Access Compliance Report

Public Rights-of-Way

(Curb Ramps)

Intersection ID: 30238	Main Street: BLUE_TOPAZ_CT	Cross Street: SILVER_ORE_LN	Location: SE
ADA ID: F0DE66EE84F1	Ramp Type: Perp	Initial Pass/Fail: Fail	Overall Compliance: No Severity Score: 33.75

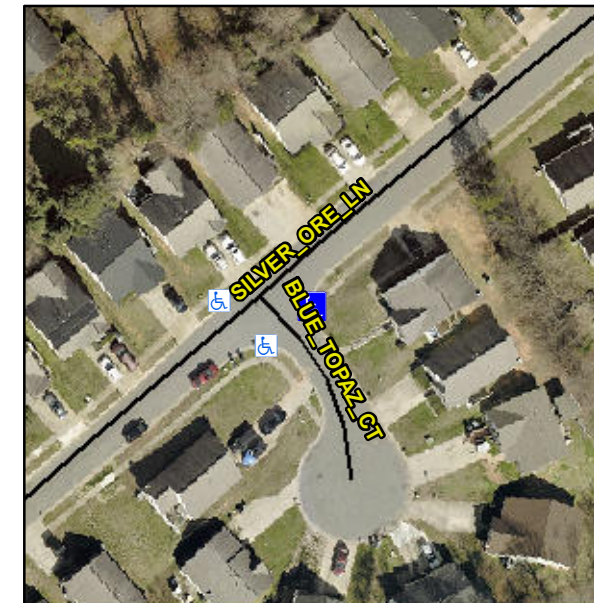
Not Found, R304.5.1, R304.5.3

Compliance	Description	Data	Compliance	Description	Data
N/A	Ramp Length (in)	59.0	Yes	Ramp Slope (%)	5.9
No	Ramp Width (in)	44.0	No	Ramp XSlope (%)	10.3
N/A	Flare Type LT	N/A	N/A	Flare Type RT	N/A
N/A	Flare Slope LT (%)	N/A	N/A	Flare Slope RT (%)	N/A
N/A	Flare Traversable LT?	N/A	N/A	Flare Traversable RT?	N/A
N/A	Landing Length (in)	N/A	N/A	DWS Provided?	N/A
N/A	Landing Width (in)	N/A	N/A	DWS Contrast?	N/A
N/A	Landing Slope (%)	N/A	N/A	DWS Length (in)	N/A
N/A	Landing X Slope (%)	N/A	N/A	DWS Full Width?	N/A
N/A	Landing Curb? (Y/N)	N/A	N/A	DWS Offset (in)	N/A
N/A	Shared Landing?	N/A			
N/A	Gutter Ponding?	N/A	N/A	Gutter Slope (%)	N/A
N/A	Gutter Lip Ht (in)	N/A	N/A	Gutter X Slope (%)	N/A
N/A	Painted X Walk1?	No	N/A	Painted X Walk2?	N/A
	X Walk 1 Direction	To SW		X Walk 2 Direction	N/A
N/A	X Walk 1 Width (in)	N/A	N/A	X Walk 2 Width (in)	N/A
	X Walk 1 Slope (%)	1.9		X Walk 2 Slope (%)	N/A
	X Walk 1 X Slope (%)	4.4		X Walk 2 X Slope (%)	N/A

Remove & Replace Entire Ramp.
